REV.	DATE	DESCRIPTION
A	10/04/2022	ISSUED FOR APPROVAL

PROJECT WACO HIGH SCHOOL
CUSTOMER Rogers O'Brien Const Co Inc
LOCATION 2020 N 42nd St, Waco, TX 76710
ARCH/ENG O'CONNELL ROBERTSON
DETAILS SECTIONS

JOB NO. 32-22017
DRWG. NO. E-3.20.2

1 SECTION
REF.: 2/S5.61

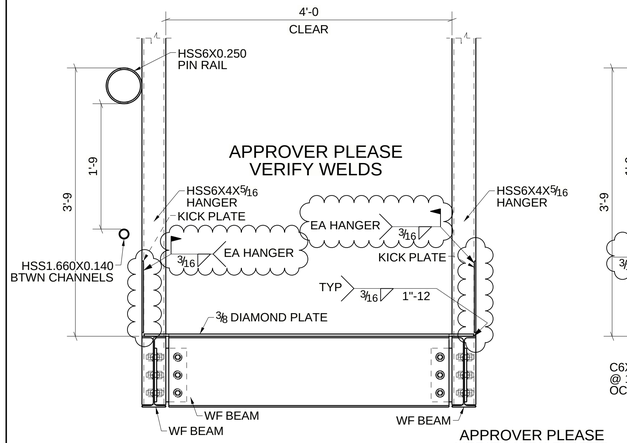
APPROVER PLEASE VERIFY KICK PLATES LOCATION (FLUSH WITH THE OUTSIDE OF HANGERS)

3 SECTION
REF.: 1/S5.61

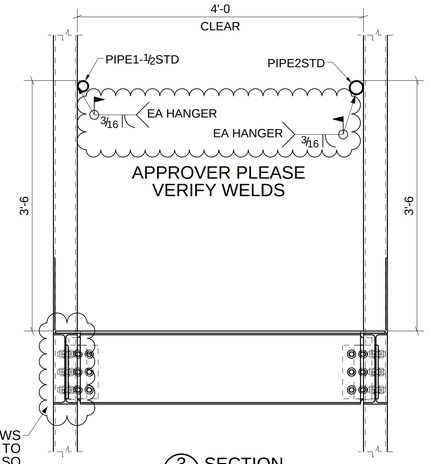
SECTION 1/S5.61 SHOWS WF BEAM IS WELDED TO HANGER BUT ALSO SHOWS SHEAR PL CONNECTION. PLEASE VERIFY WHICH ONE IS CORRECT.

5 DETAIL
REF.: 4/S1.42

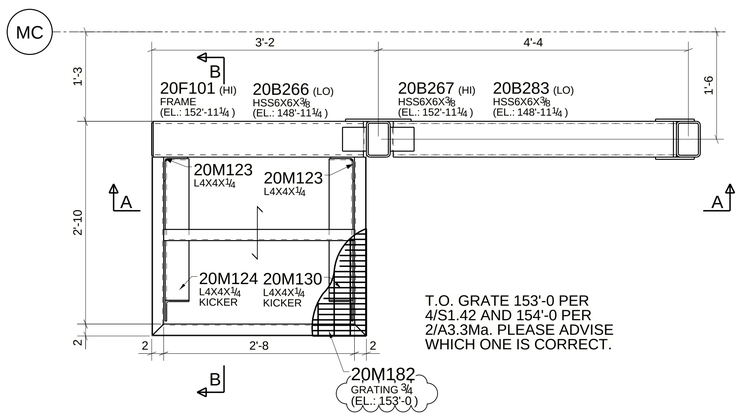
T.O. GRATE 153'-0 PER 4/S1.42 AND 154'-0 PER 2/A3.3Ma. PLEASE ADVISE WHICH ONE IS CORRECT.

PLEASE VERIFY IF IT IS ACCEPTABLE TO ROTATE CHANNEL TOE OUTSIDE TO ALLOW WELDING OF HIRIZONTAL ANGLE AND KICKER.

MOMENT CONN. PLATE CLASHES WITH GRATING. PLEASE VERIFI IF IT IS ACCEPTABLE TO CUT GRATING AROUND PLATE

7 SECTION

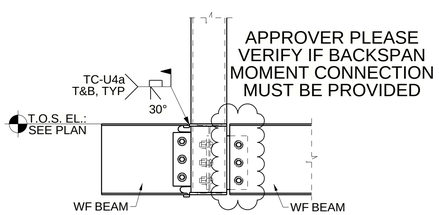
APPROVER PLEASE VERIFY IF BACKSPAN MOMENT CONNECTION MUST BE PROVIDED

8 SECTION

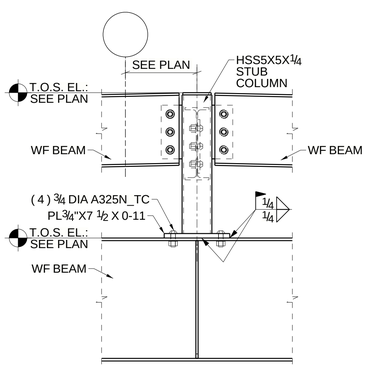
APPROVER PLEASE VERIFY SOLUTION
